**LEGAL ADVERTISEMENT
HISTORIC PRESERVATION BOARD
CITY OF PORTLAND
Public comments are taken at all meetings.**

On Wednesday, November 5, 2014 at 5:00 p.m., the Portland Historic Preservation Board will meet in Room 209 to review the following items:

CITY OF PORTLAND, MAINE
HISTORIC PRESERVATION BOARD

WINDOWS
PROPOSED
FOR
REPLACEMENT

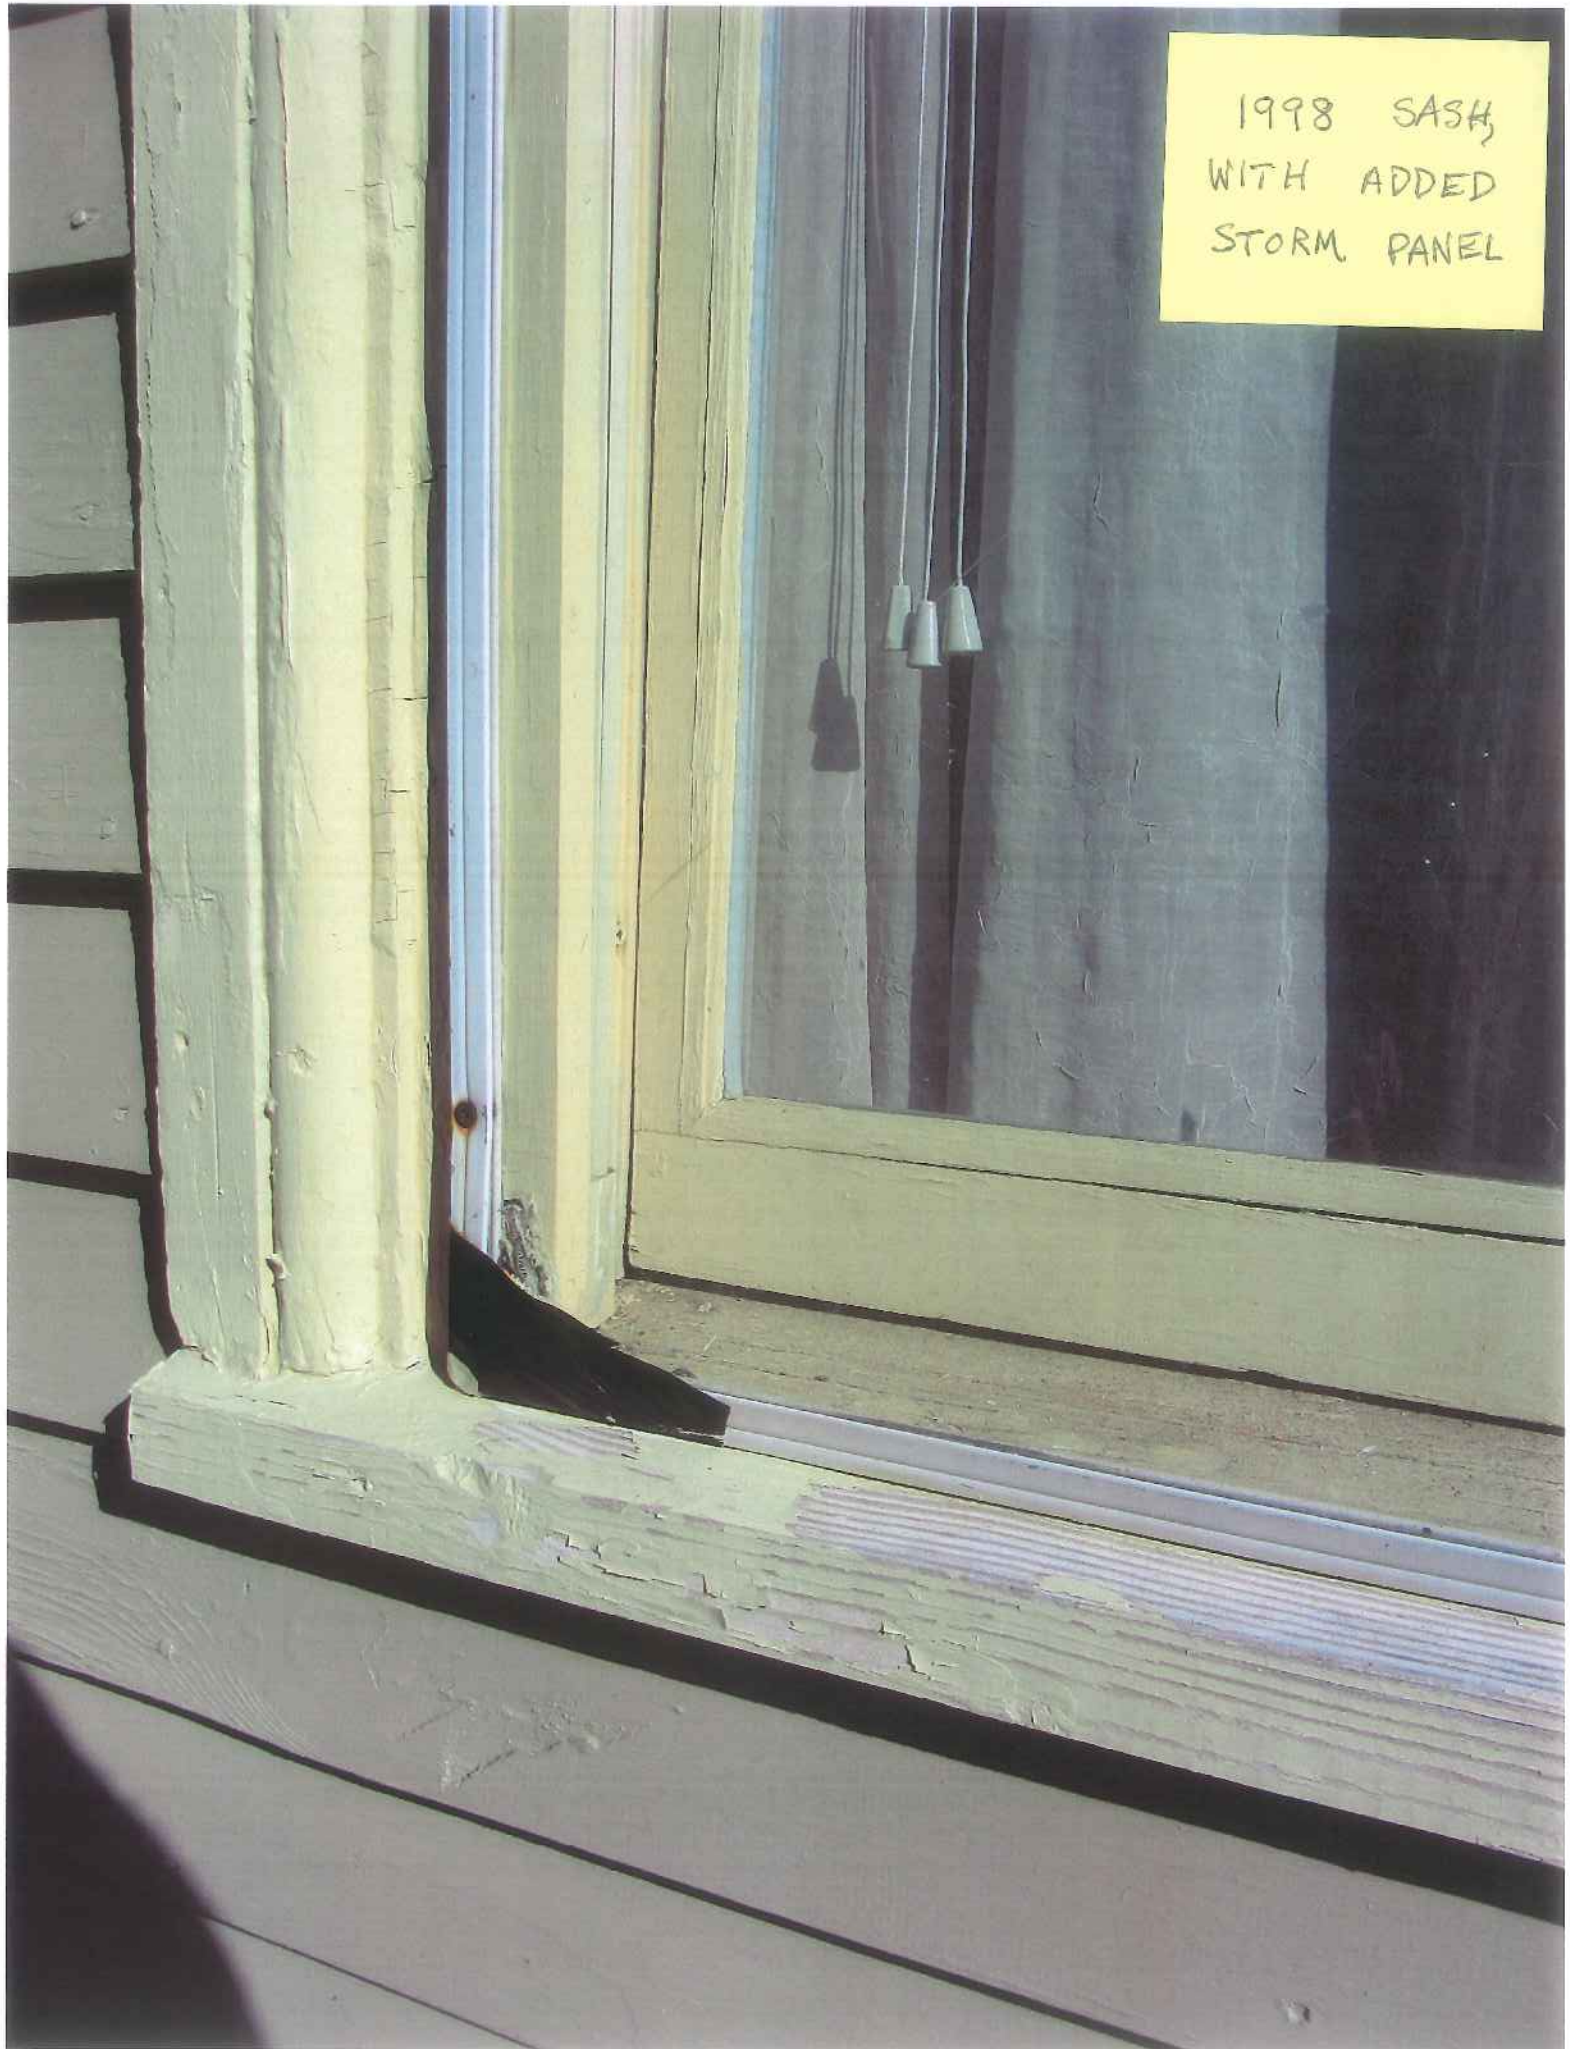
While several Board members were favorably impressed by the design and appearance of the Andersen Renewal units, the applicants faced questions about the narrower daylight opening offered by the Renewal inserts. It was pointed out that a commonly accepted solution in similar situations has been the same treatment as in most of the existing windows at the property – sash replacement kits with new jamb liners. Concern was expressed about potentially establishing a new precedent with this project, by permitting composite insert windows that compromise the daylight opening.

- New storm windows would change the exterior appearance of the windows, but could match the color of the trim, and may be available in a configuration that does not compromise the existing daylight opening. (The applicants appear to believe that new storm windows would inevitably decrease the daylight opening.)

On the basis of plans and specifications submitted by the applicant for the 11-5-14 Public Hearing and information included in the accompanying staff report, the Board finds that the proposed window replacement at 70-72 Emery Street **meets (fails to meet)** the historic preservation ordinance's review standards, specifically Standard # 6, (subject to the following conditions.....)

NOTICE OF RIGHT TO CANCEL

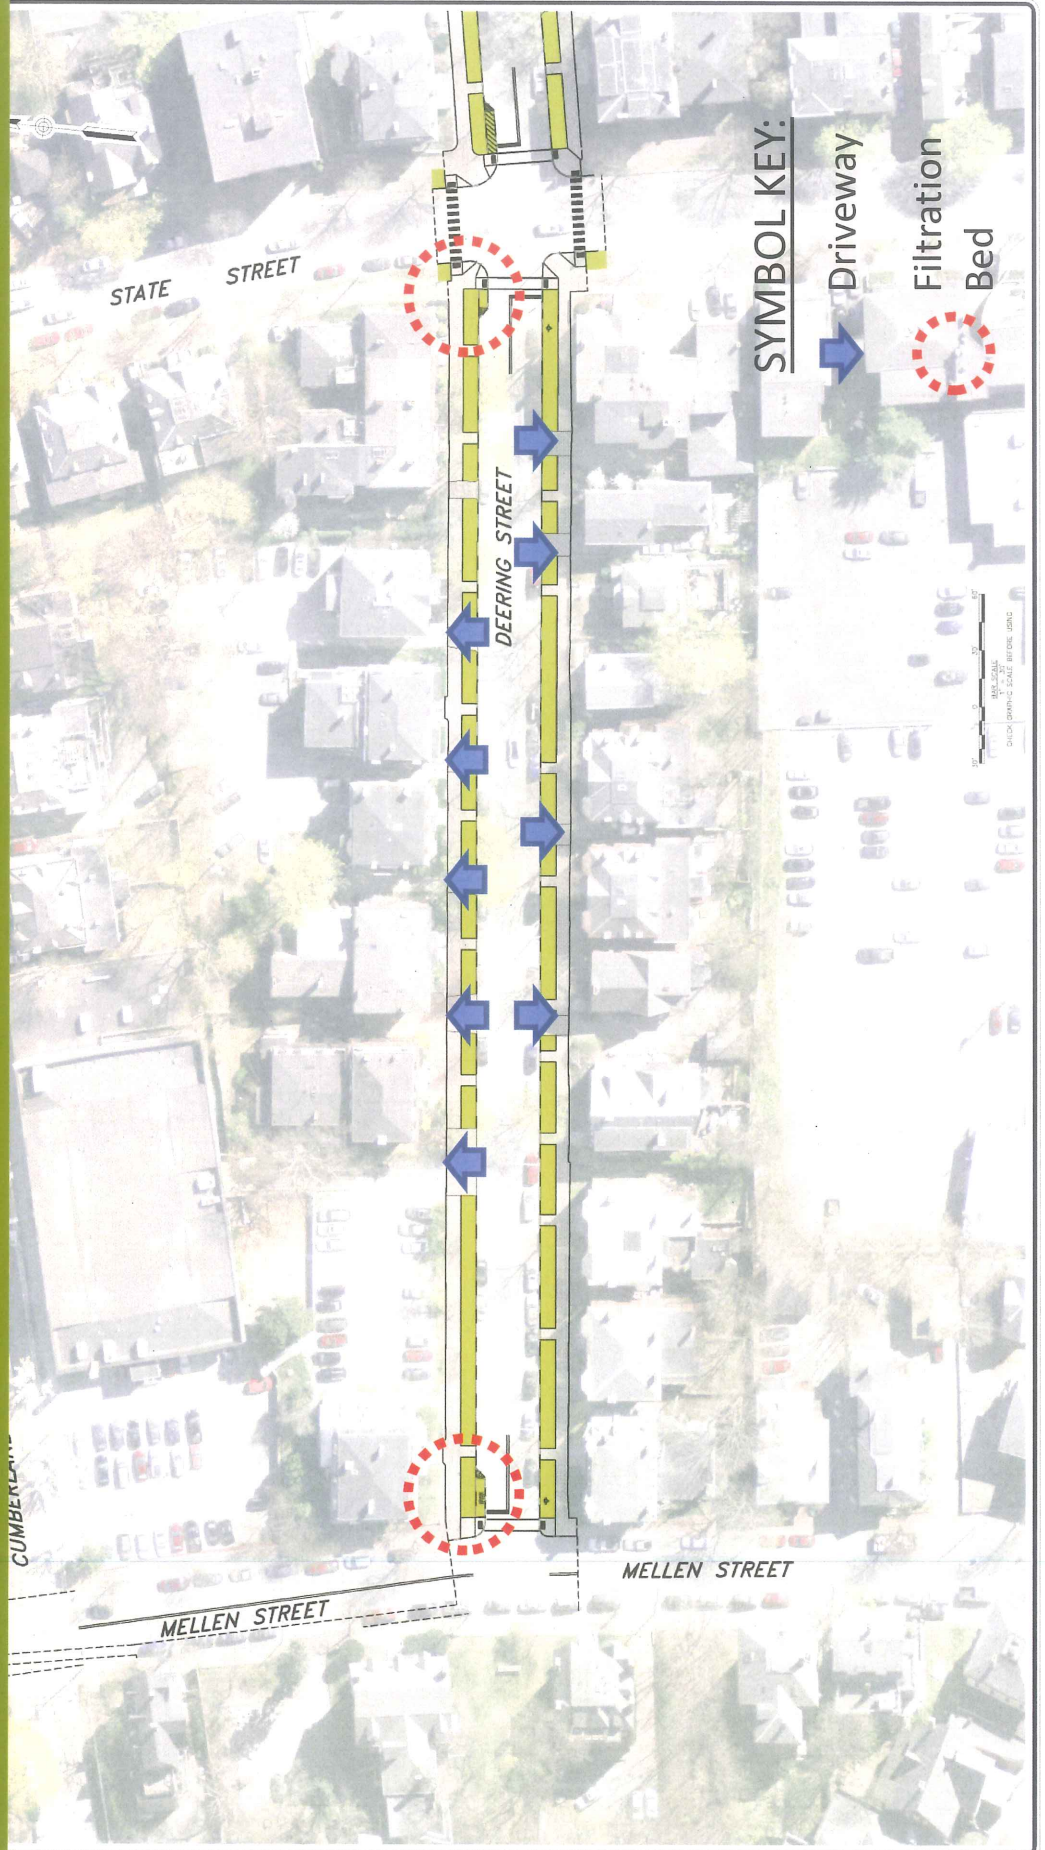
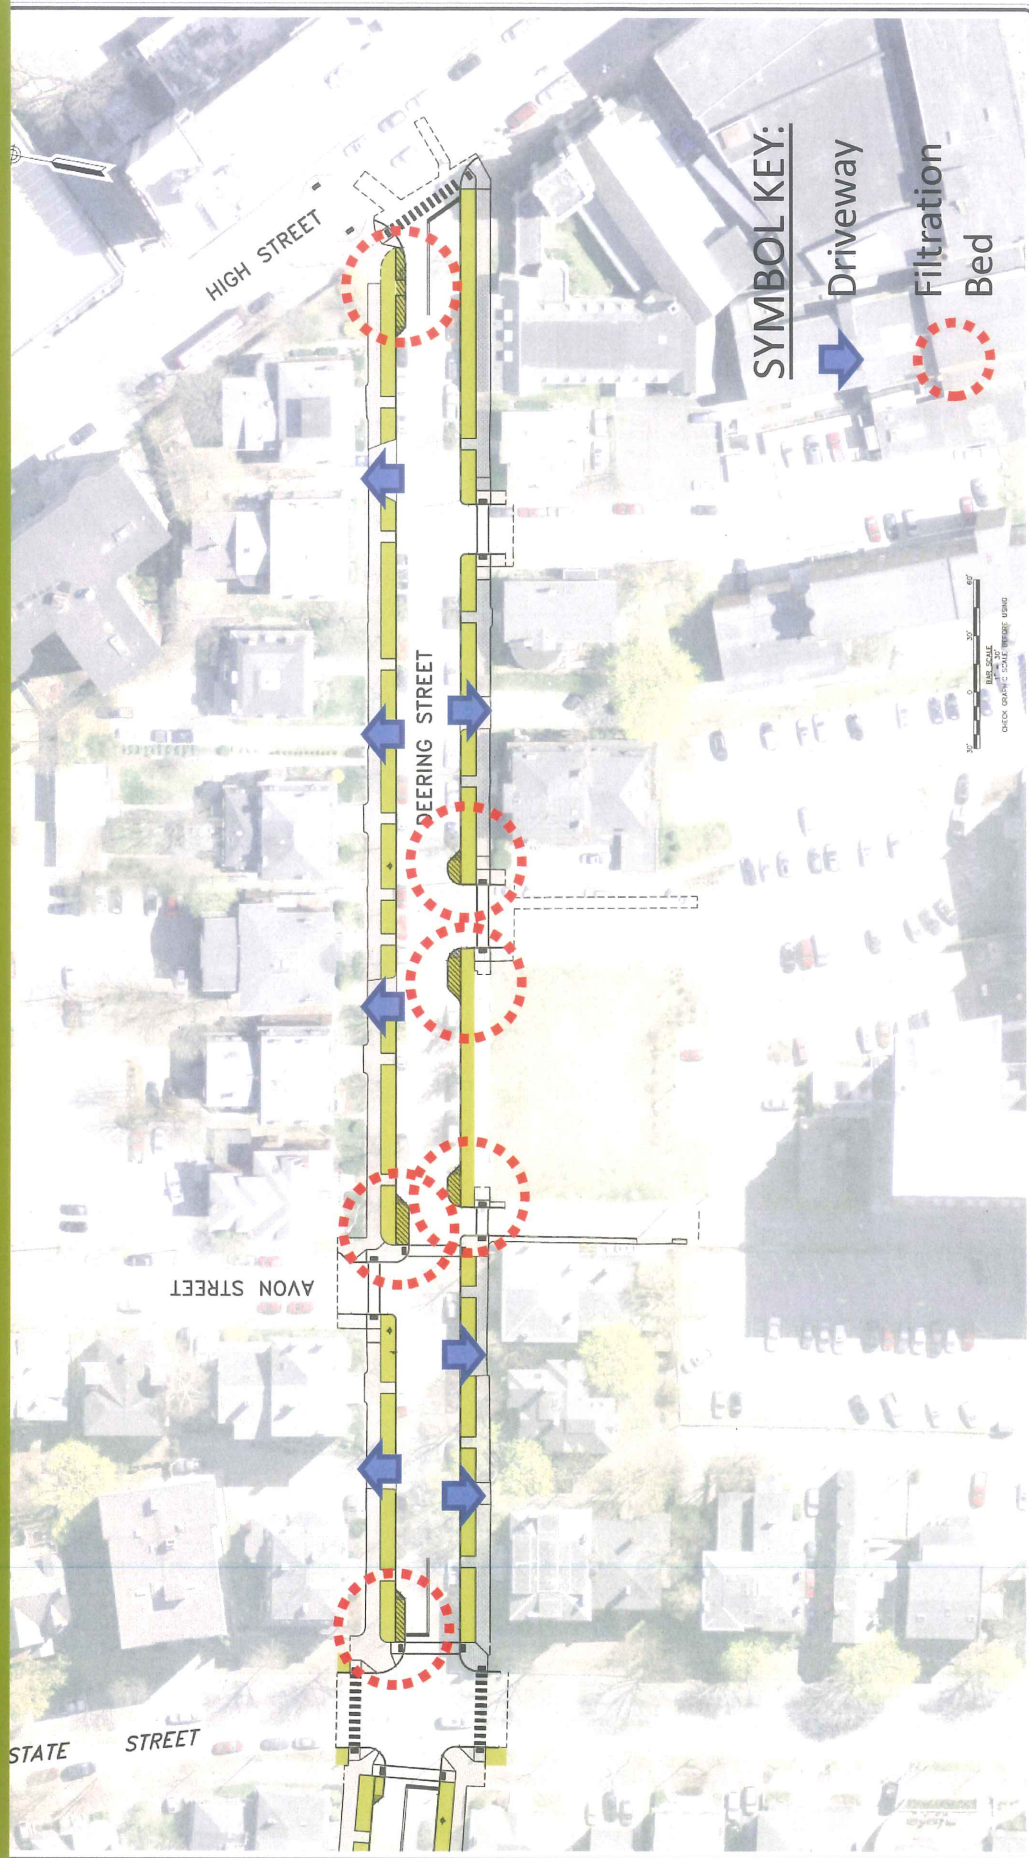
At the June workshop, the Board expressed a number of concerns about the plan as proposed and its impact on the historic character of Deering Street, which all members agreed is one of the most visually compelling and intact historic streetscapes on the Portland peninsula. Several members of the public also raised a variety of concerns with the proposed plan. Board members questioned the proposal to replace a number of the existing historic streetscape features, including curbing, with new material of a different dimension and/or character. They also expressed significant reservations about the alterations within the street right-of-way which were proposed to treat stormwater runoff. Board members were concerned that the added infrastructure elements would materially alter the historic character of the street, which is noteworthy for its consistency. That said, Board members responded

The Public Services Department is committed to a City-wide integration of "green" storm water components to pretreat and minimize runoff. In response to Board comments that the proposed treatment seemed lop-sided, the Department investigated the feasibility of adding curb extensions on the southern side of Deering Street. While these areas would not provide any storm water function, they would mirror the curb line on the opposite side of the street, particularly at key intersections. The City's traffic engineer reviewed the turning movements and determined that narrowing the travel lane further is not feasible in these locations, particularly in consideration of snow loading. For this reason, the Department is moving forward with the locations originally proposed. As requested by the Board, the design team has prepared photo renderings showing several views of the planted curb extensions. Please reference the enclosed images.

In response to Board comments, the Public Services Department has authorized the use of "straight-backs" or "bugs" at driveway corners rather than the standard tip-downs used for other neighborhoods. Existing bugs that are in acceptable condition will be reset. In light of feedback from the Board, the Public Services Department is amenable to resetting the existing granite curbing along the existing street edge. Replacement curbing, if necessary, will be sourced to match the width and coloration of the existing curb. New granite curbing meeting the standards outlined in the Technical Manual will be used for proposed curb extensions. Curbing will be specified with a beveled edge to minimize chipping.
